Item 4.**Development Application: 21 Missenden Road, Camperdown**

File No.: D/2020/917

Summary

Figure 15: Proposed ground floor/Level 1 plan

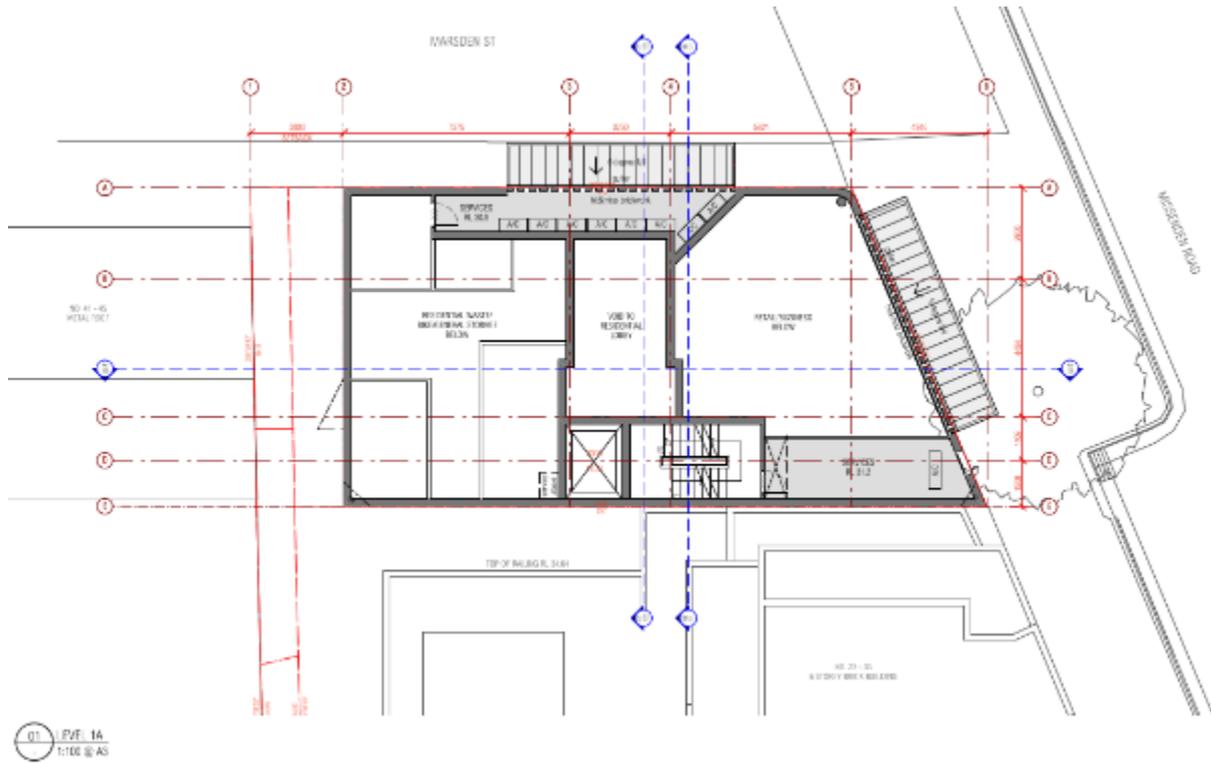
Common open spaces are provided to ground floor level (referred to as Level 1 on the plans), level 2 and level 5. The communal open space is not consolidated into one useable area and the ground level space does not meet the minimum 3m dimension in accordance with the ADG.

Provision	Compliance	Comment
3.1 Public Domain Elements	No	<p>The proposed residential entry lobby opens onto a narrow footway on Marsden Street which is currently approximately 1.2m wide. This width is not considered to be an appropriate width for the primary entry to a development of this scale in this location. In this regard it is noted that existing traffic signposts within the footpath currently obstruct the pedestrian path of travel.</p> <p>Were the application to be supported it is considered that the footpath would need to be widened, which would impact on current traffic conditions. This would require the approval of the traffic committee. In this regard it is appropriate that the applicant investigate the necessary footway improvements and changes to traffic conditions prior to the determination of the application.</p> <p>The proposed residential lobby is set at RL27.9 which is below the existing top of kerb which is at RL28.06. The level changes have not been accommodated within the property to align with the public domain and has not demonstrated whether residential access complies with the Disability Discrimination Act.</p> <p>The proposal does not ensure that the development makes a positive contribution to the public domain.</p>

Figure 28: Photomontage and elevations of the original proposal lodged on 15 September 2020

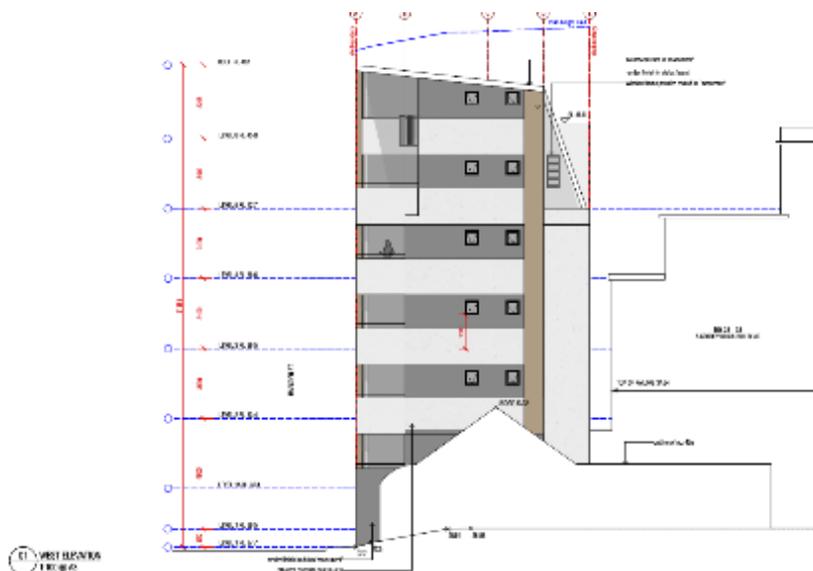
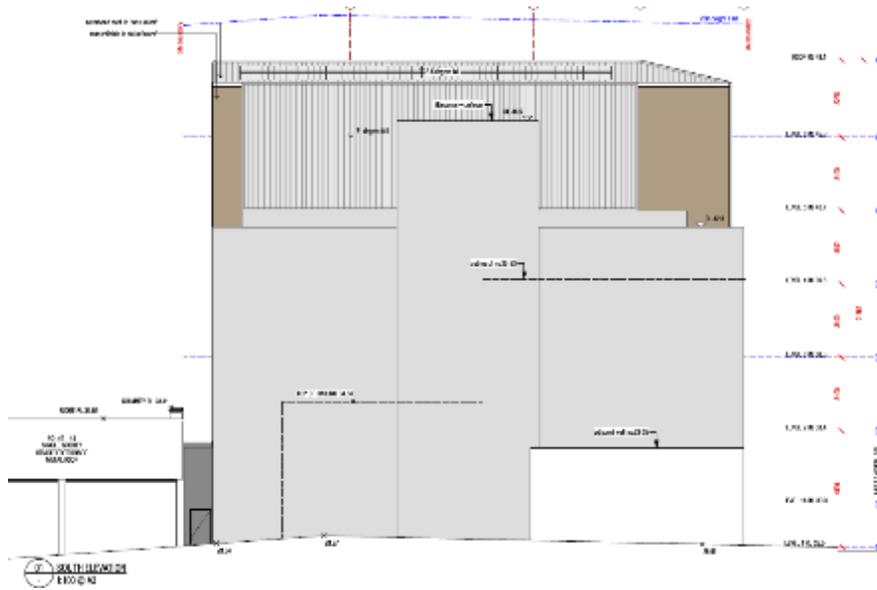
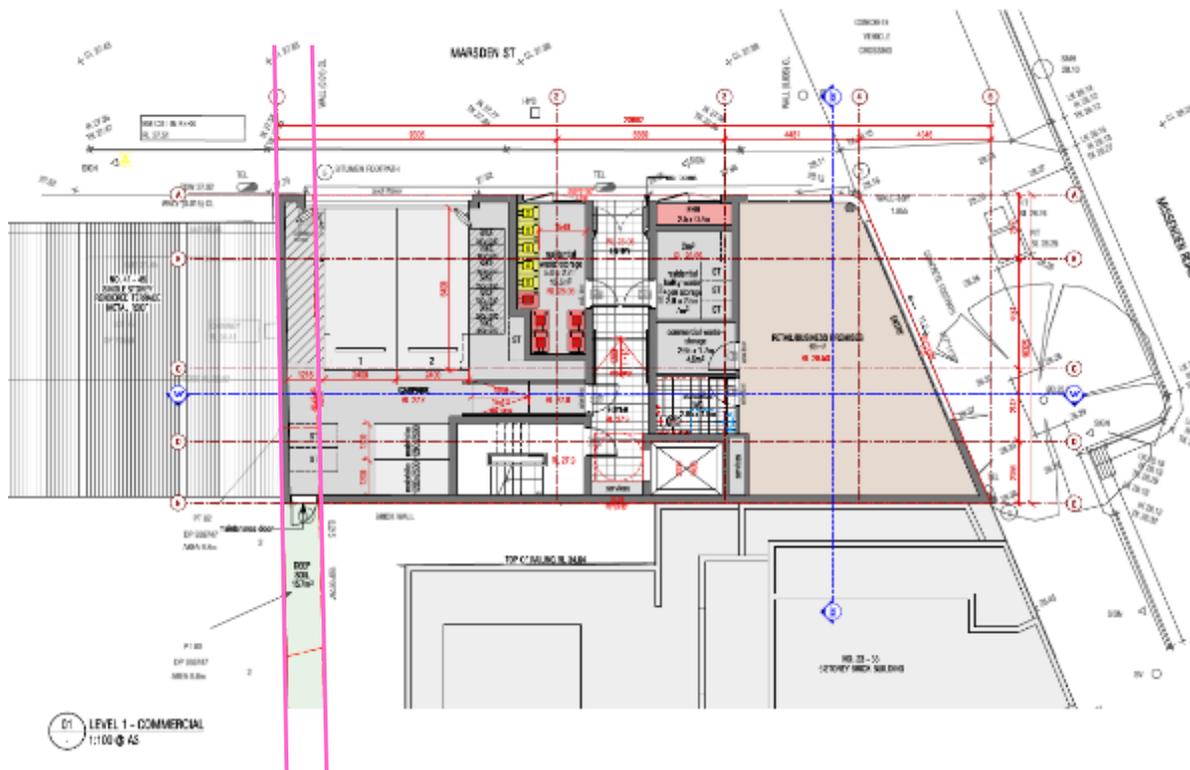
- (a) the development is over the maximum permitted floor space ratio and height in storeys with minimal setbacks;
 - (b) insufficient building separation from the western elevation being 1.2m from 45 Marsden Street limiting potential future uses for the adjacent site and poor amenity for the occupants;

- (c) inadequate landscape design with the deep soil area being located only to part of the 1.2m wide strip of land at 45A Marsden Street which is inadequate in providing any appropriate and meaningful landscaping;

- (d) elevations lack detail and architectural expression;
 - (e) poor residential entry/street level design;
 - (f) inadequate solar access diagrams demonstrating impact to neighbouring properties;

- (g) proposed garage and parking layout arrangement is not workable with insufficient clearances provided for manoeuvrability between the different modes of transport. Insufficient bicycle parking and the double garage frontage is not supported;

- (h) undersized communal open space area;
 - (i) waste room vents to residential entry resulting in poor amenity to occupants and visitors. Inadequate waste storage areas and access;

- (j) no sunhoods provided to windows to reduce heat load and provide weather protection;
 - (k) awnings not provided to both frontages;
 - (l) inadequate details on the materials, finishes and colours, window operability, gutters and downpipes and services;

- (m) adverse privacy impact from balconies and windows on the western elevation; and
 - (n) unit 3 apartment area and balcony is undersized.
13. On 15 February 2021, the applicant advised that they would not withdraw the application and instead would amend the proposal to no longer include the site at 45A Marsden Street.

14. The final revision was submitted to Council on 5 March 2021. These plans are the subject of assessment in this report. The key changes to the scheme are:

- (a) removal of 45A Marsden Street;
 - (b) removal of 2 apartments (previously Units 1 and 3) resulting in the development being compliant with the FSR, Building Height and height in storeys controls;

- (c) greater setback from the western boundary and now being setback between 2-3m from the neighbouring terrace at 45 Marsden Street;
 - (d) provision of 17sqm of deep soil area;

- (e) changes to the facade treatment and materiality and roof design;
 - (f) reconfiguration of the ground floor level (referred to on the plans as Level 1) to:

- (i) remove car and motorcycle parking from the development and no longer propose a vehicular crossover from Marsden Street;
 - (ii) provide a larger residential lobby with a sense of address and entry from Marsden Street;

- (iii) provision of more residential storage cages;
 - (iv) adequately sized and sited waste and bulky storage rooms; and
 - (v) provision of 11 bicycle parking spaces.

- (g) additional communal open space provided, totalling an area of 51sqm;
 - (h) addition to the facades of weather protection, including sunhoods and louvres provided to windows on the east and north elevations and inclusion of awnings provided to both frontages/entries to the building;

- (i) further details provided on the materials, finishes and colours, window operability, gutters and downpipes and services; and
 - (j) inclusion of a western elevation wall to the balconies in the north-western corner of the development for Units 1, 3, 5, and 7.
